Technical Service Information

THM 3T40 (125C) NEW GOVERNOR COVER AND BEARING

Figure 1

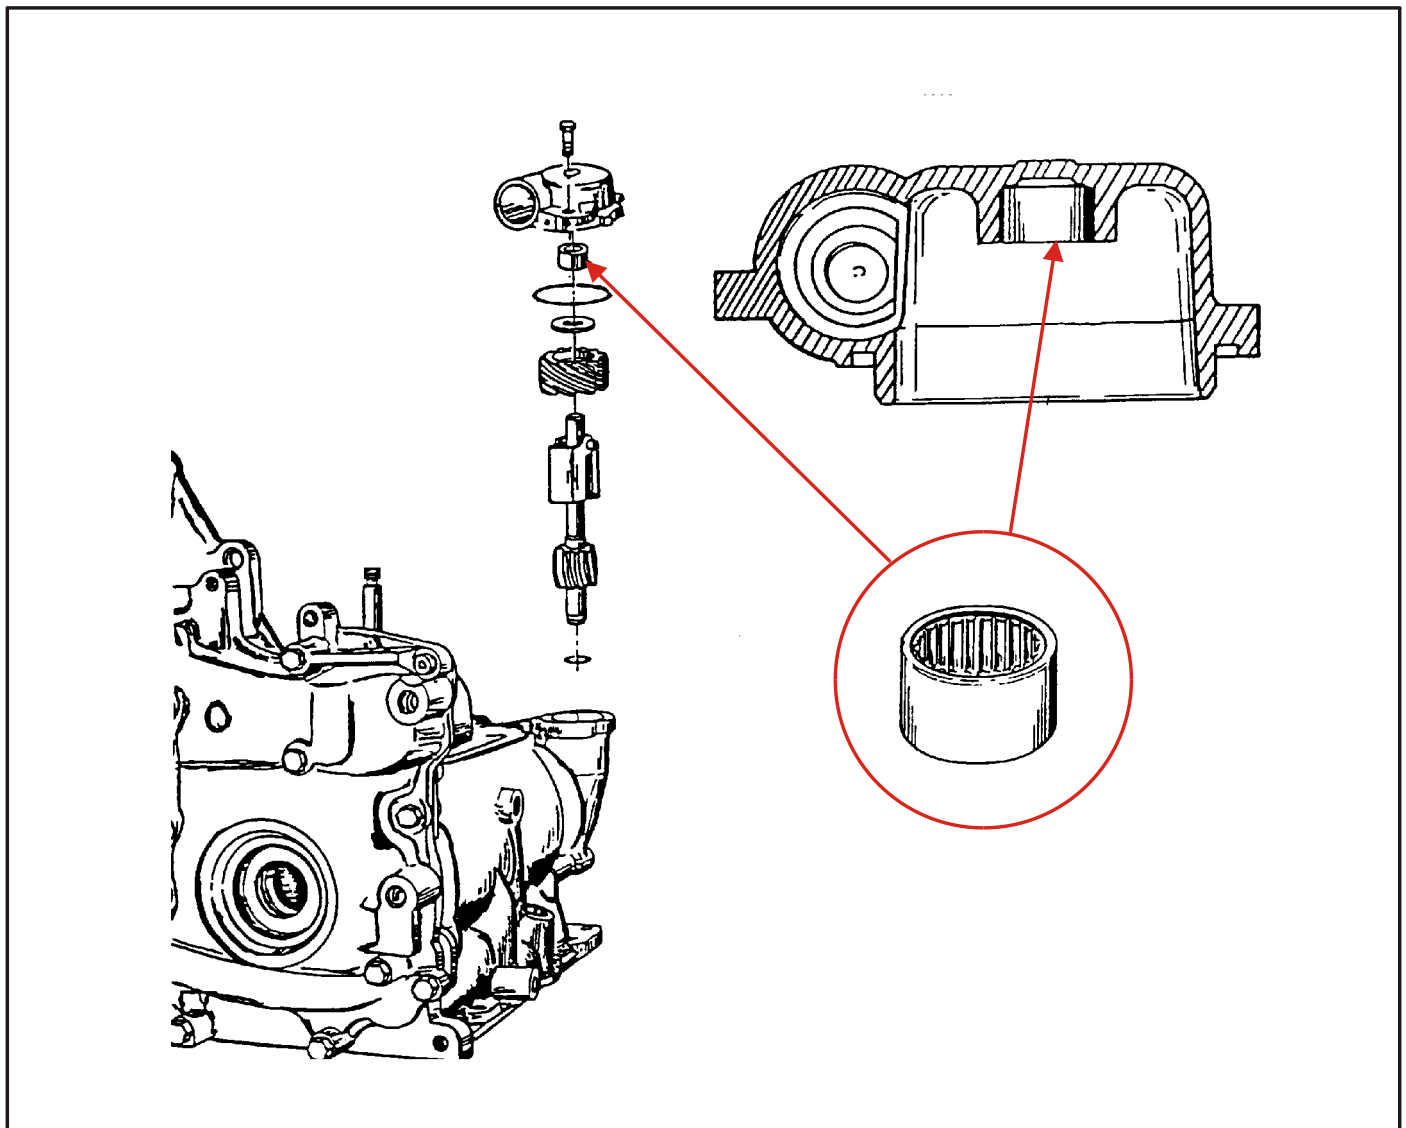
A caged needle bearing has been added to the governor cover beginning in model year 1986 (See Figure 1).

The new governor cover and bearing assembly will interchange with pre-vious models, as an assembly.
